# OICA proposal for « universal booster seating position » within the R129 regulation

OICA requires **Universal Booster Seat Gabarit** to fit universal vehicles

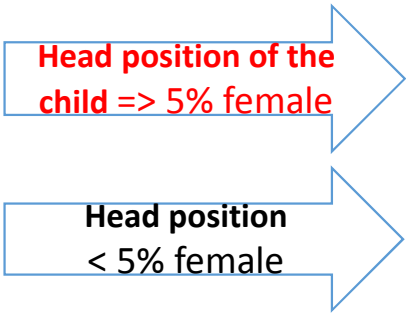
- UN R14: minimal **width** between buckles = **350 mm**
- **5% female hip width: 300-315 mm**

**550 > 350 !**

Even without the ISOFIX links connected, the width of the ISO gabarit interferes with vehicle dimensions.

*This concept will not work out as long as Universal Booster Seat Gabarit is not fitting into the car dimensions!  
Safety **Belt Routing** is also not solved.*

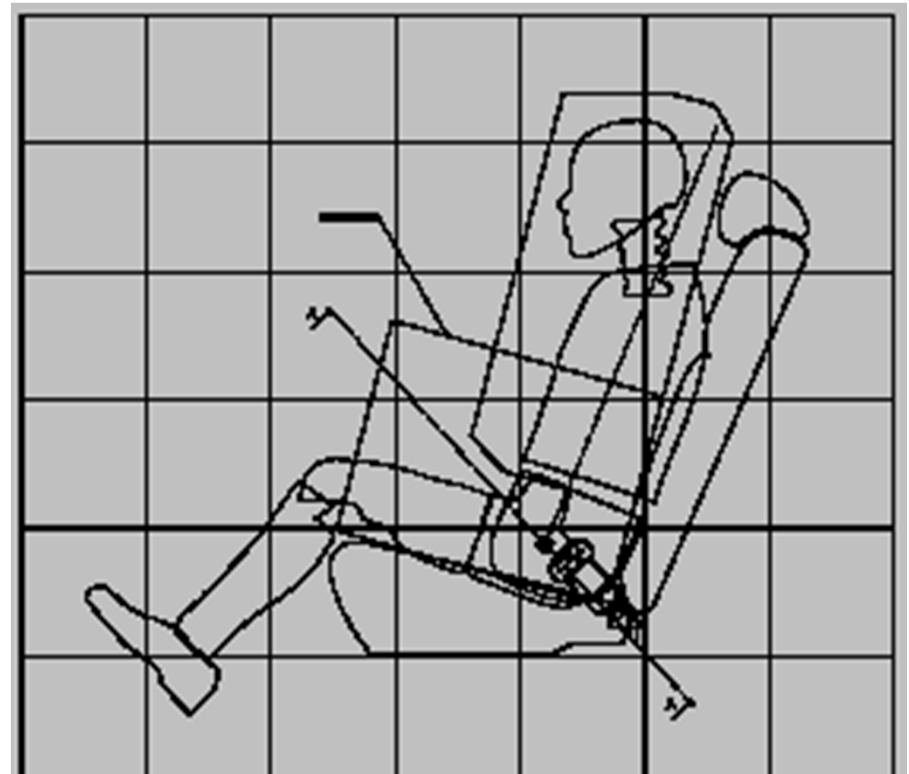
**Universal:** ISO Universal Booster Seat Gabarit height has to be for ≤ 120 cm child size, which means ≤ 770 mm height.

Height & width of the ISO booster seat gabarit				
		height (cm)	sitting height (cm) 95%	hip width (cm) 95%
	Q6	105	61,8	
	Q6	120	68,1	
depending of the cushion	Q6	125	70,2	30,5
proposal:	maximum height	135	74,4	33,3
			sitting height(cm) +- 9mm	
	Q6		60,1	
	Q10		74,8	
	AF5		78,5	
	F3		72	
	iso booster		80

The small woman is seated inside the ISO gabarit!

We propose Q6 stature seated a universal booster seat gabarit.
